REQUEST FOR ACTION (RFA)			
1. Review Type TKUP System Requirements Review		2. RFA No. 452/230-001	
3. Review Date April 27, 2005			
4. Title Link Margin

REQUEST FOR ACTION (RFA)			
1. <i>Review Type</i> TKUP System Requirements Review		2. <i>RFA No.</i> 452/230-002	
3. <i>Review Date</i> April 27, 2005

Figure 1. 1.2 Meter Antenna With 2 dB Link Margin

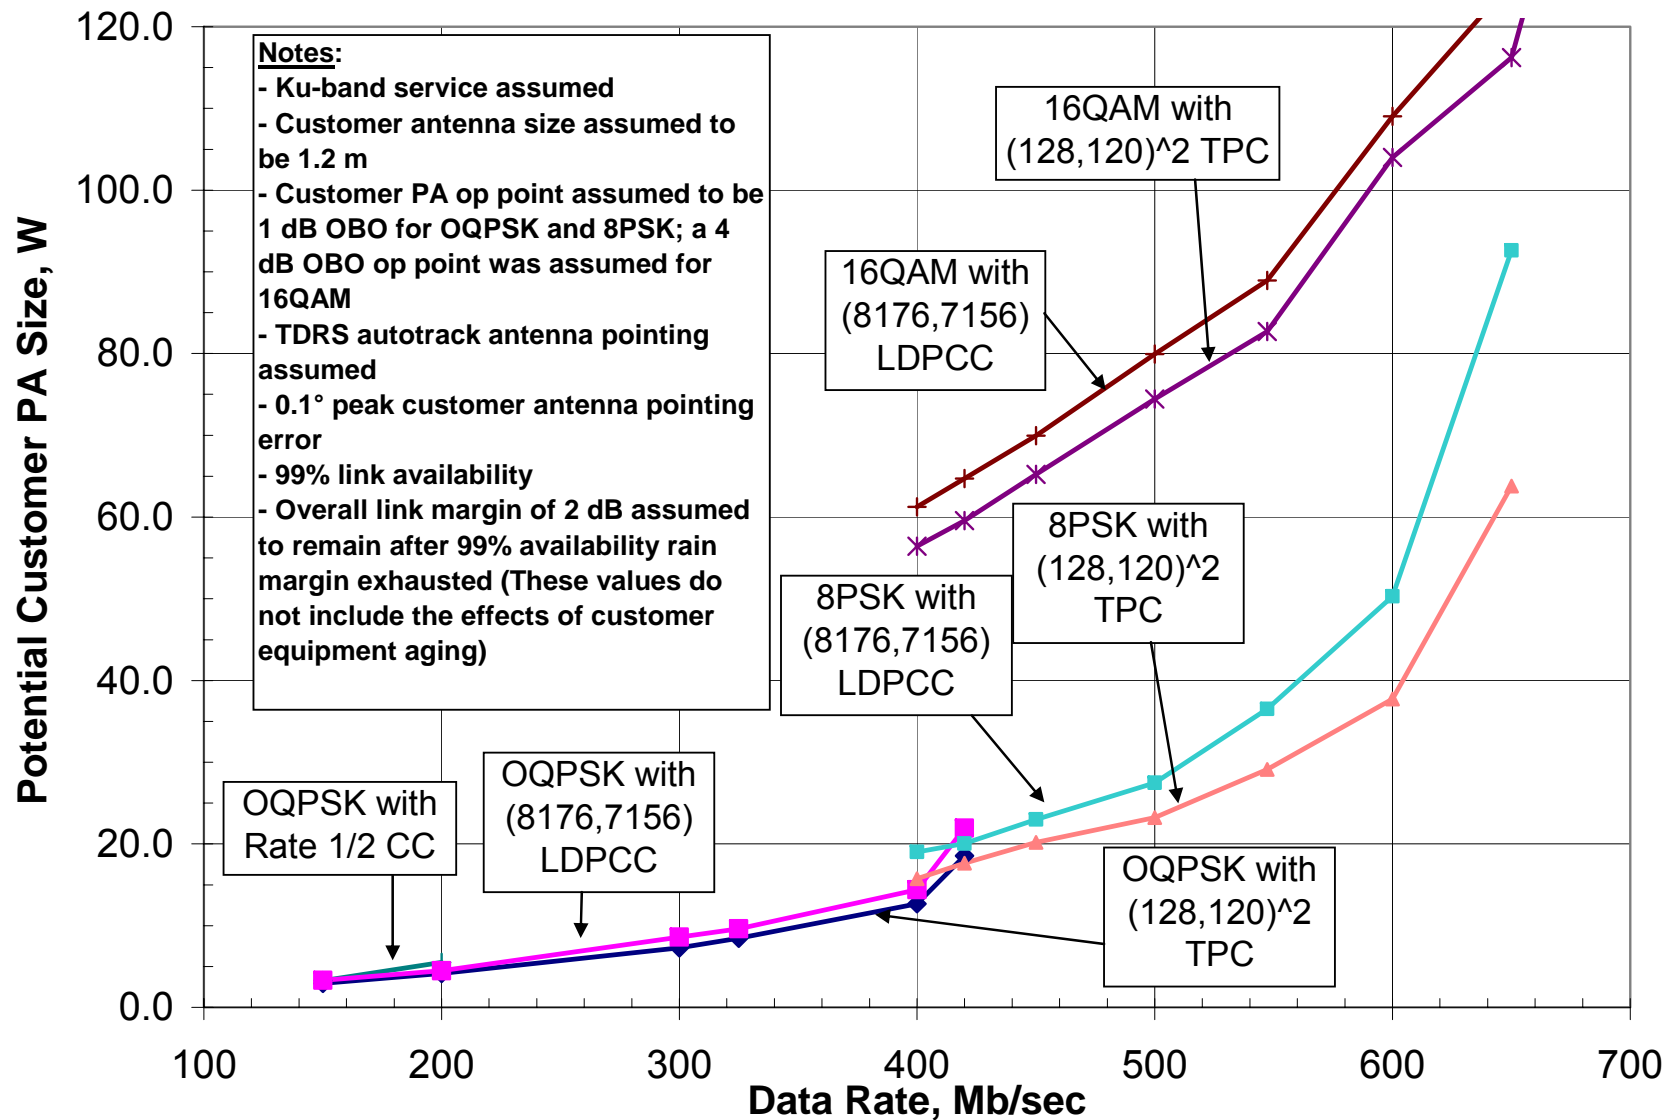
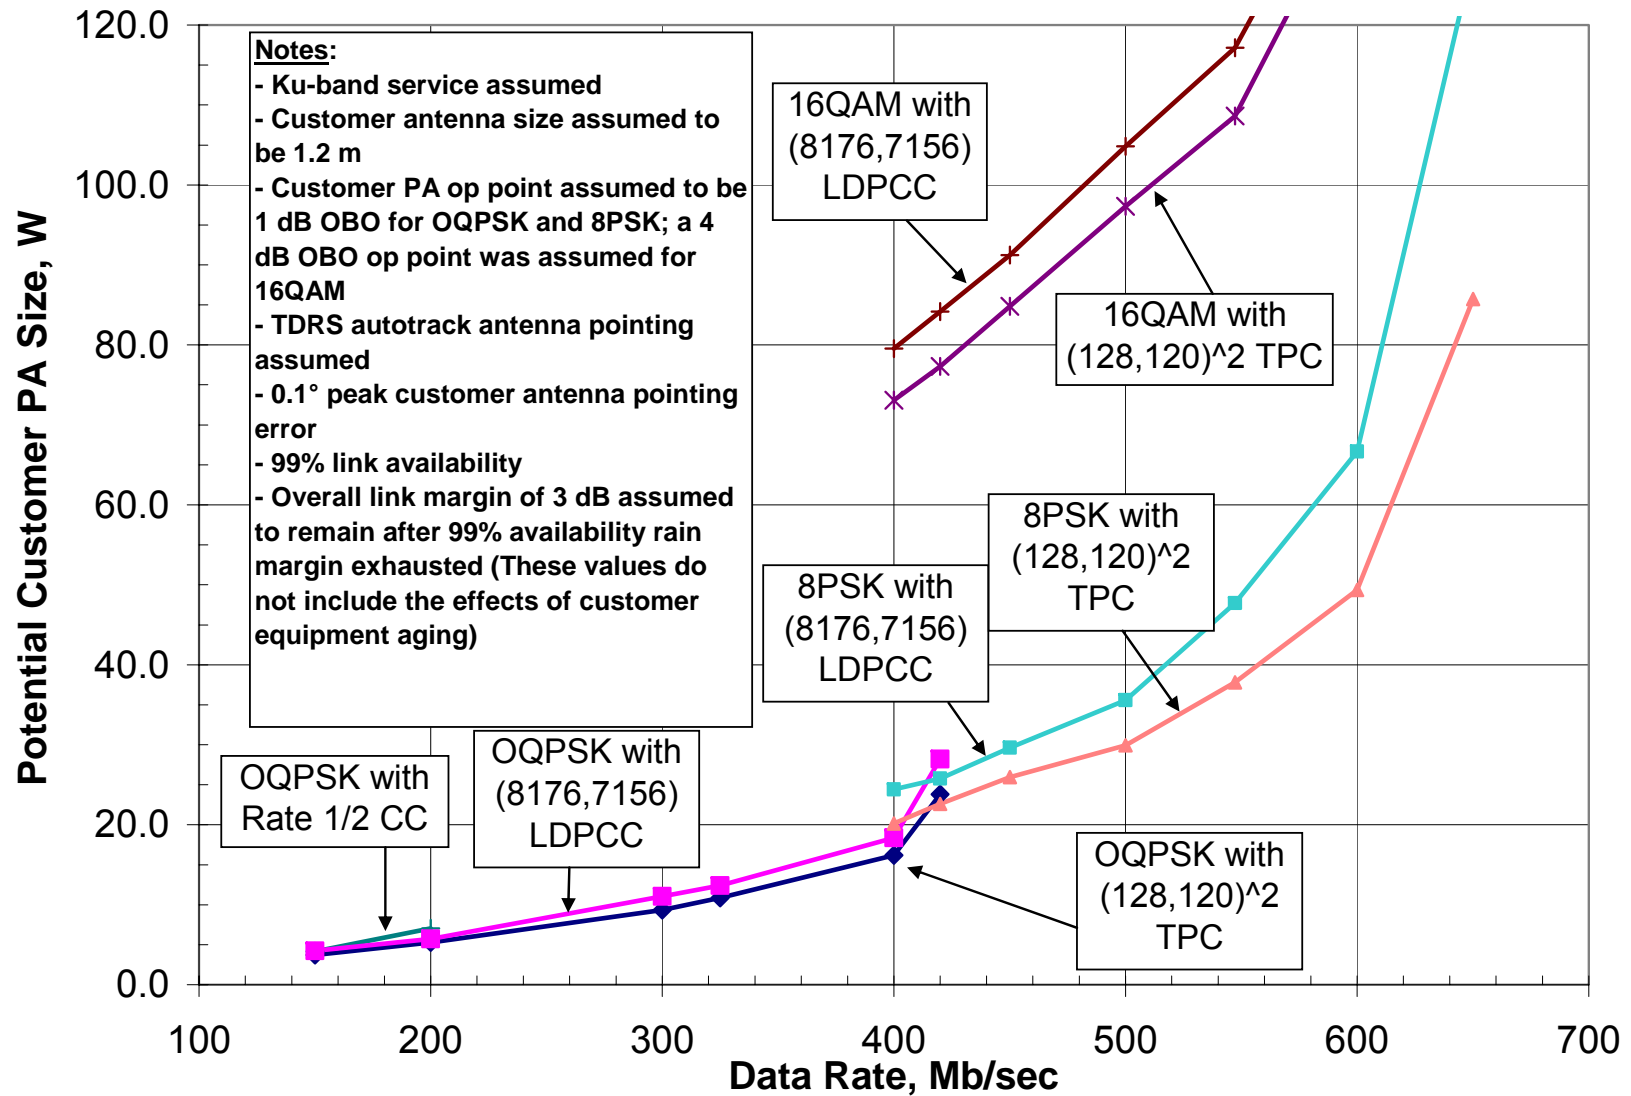
5. Action Change the link margin used from 2 dB to 3 dB and make it clear that the margin is to be provided by a flight project using TKUP. This is link margin specified by Table 1.06-1 of "Rules for the design, Development, Verification, and Operations of Flight Systems" GSFC-STD-1000. Goddard Procedural Requirement (GPR) 8070.4 directs all space flight products for which GSFC is responsible to conform to the rules stated in GSFC-STD-1000 unless acceptable waivers are obtained.			
Reference Page 11, identifies a 2 dB margin

8. Response The customer PA size as a function of data rate is attached for a 2 dB link margin (Figure 1) and a 3 dB link margin (Figure 2) when using a 1.2 meter antenna. As expected, the required PA size is higher for a 3 dB link margin. The TKUP has a responsibility to submit recommended SNUG modifications to SN management based on the TKUP upgraded services and equipment. The 3 dB link margin specified in GSFC-STD-1000 will be included as appropriate in the proposed SNUG modifications. During the development of the TKUP requirements, TKUP used the Modulation & Coding study to determine the maximum data rate that the TKUP receivers should support for all non-NASA and NASA customers. The potential non-NASA 2 dB link margin customer actually drives the TKUP maximum data rate requirements, not the 3 dB link margin customer. Therefore, the TKUP Requirements Specification (RS) does not require any changes even if NASA customers are restricted to 3 dB link margins. NASA customers, who must use 3 dB link margins, may want to use 600 Mbps rather than 625 Mbps in order to keep their PA size lower, but the TKUP receiver (TKUP RS) should still support 625 Mbps for non-NASA customers who may want to operate with a 2 dB link margin. Also, the point at which 8PSK starts to outperform SQPSK (410 Mbps) is not determined by the link margin parameter. Therefore, the SQPSK to 8-PSK crossover point will not change when the link margin is changed from 2 dB to 3 dB. That point is determined by the channel distortions and by how much the main lobe of the signal spectrum is filtered.

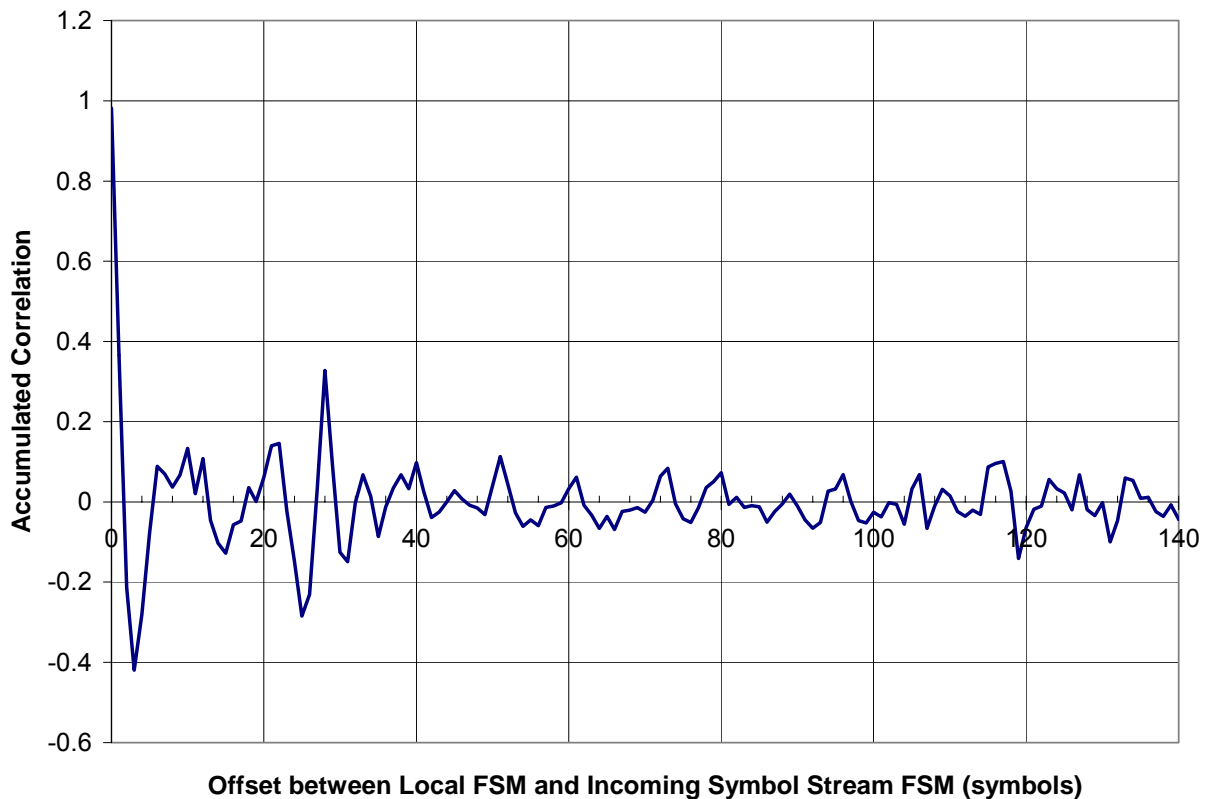
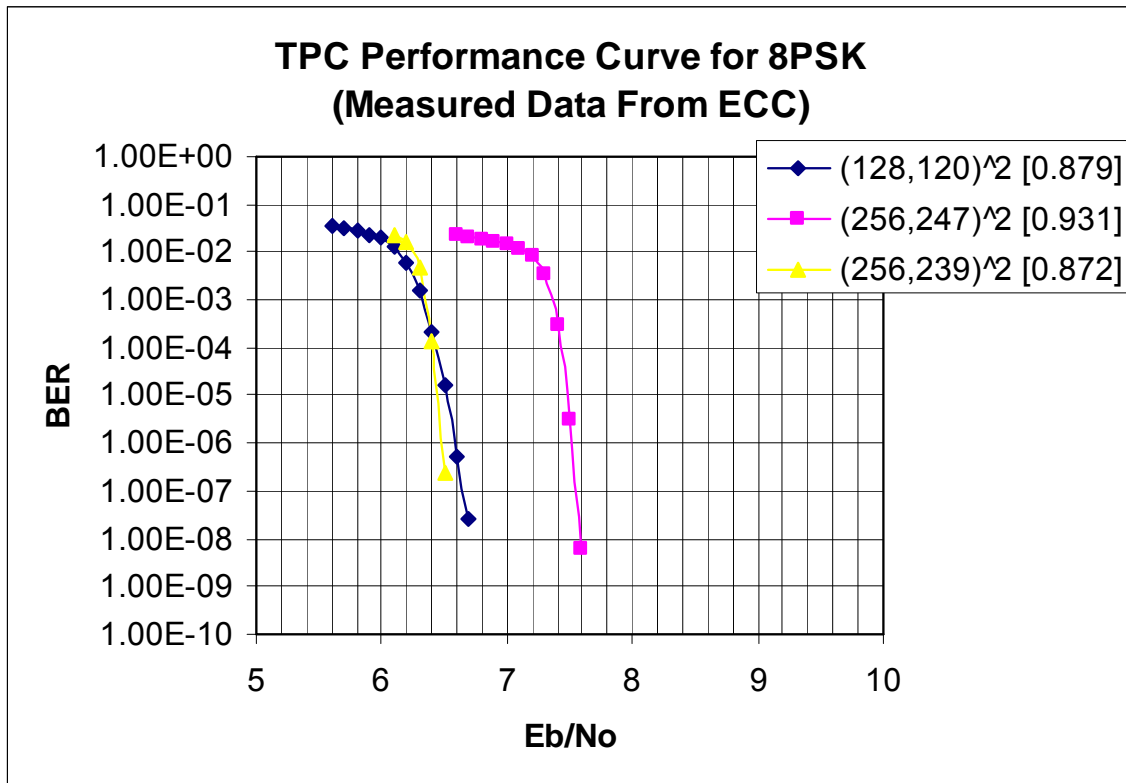
4. <i>Title</i> Symbol synchronization for long code lengths			
5. <i>Action</i> Determine if there is a need for either longer synchronization headers or pilot words for long code lengths in order to maintain symbol synchronization, especially 8PSK modulation and what impact to receiver quality (if any) without pilot words. DVB-S2 requires pilot symbols for 64K blocks.			
Reference Page 81

The following plot provides insight into the statistics of the accumulated correlations for a selection of the 65578 alignment states:

Based upon the results of these acquisition simulations, it should be clear that decoder acquisition is certainly feasible with a 42 bit length FSM, even if the larger block TPC code is utilized.

Figure 3. 0.8 Meter Antenna With 2 dB Link Margin

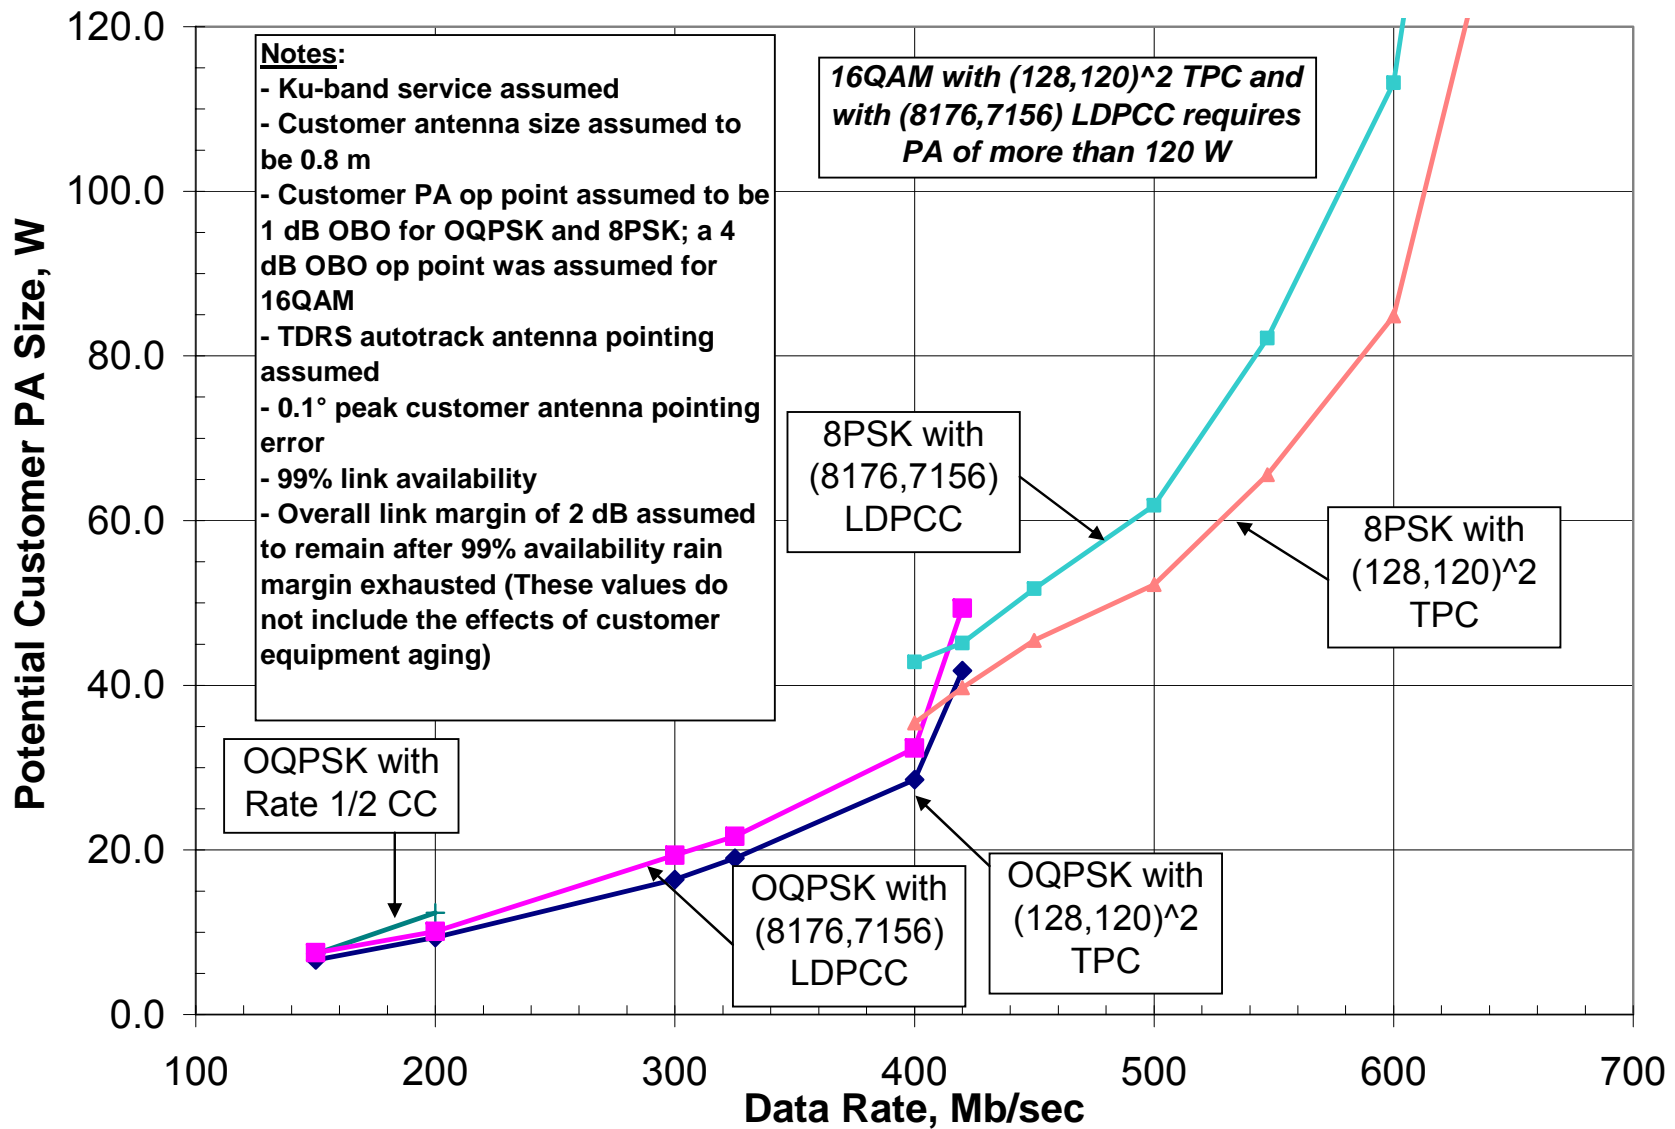
4. <i>Title</i> Question about modulation and coding for commercial data rates from smaller antennas			
5. <i>Action</i> Run the simulations to determine modulation and coding recommendations for OC-3 (155 Mbps), dual OC-3 (310 Mbps), and OC-12 (622 Mbps) from smaller antennas. (i.e., What modulation and coding would be best for the customers at those data rates?)			
<div>Reference</div> <div>Page 11, TKUP Modulation and Coding Study</div>

622 Mbps can not be supported with a 0.8 m antenna and PA sizes below 100 Watts. However, based on the attached plot, Figure 3, data rates up to about 622 Mbps can be supported with a 0.8 m antenna and a 120 Watt PA if the customer uses 8-PSK, TPC coding, and a 2 dB link margin.
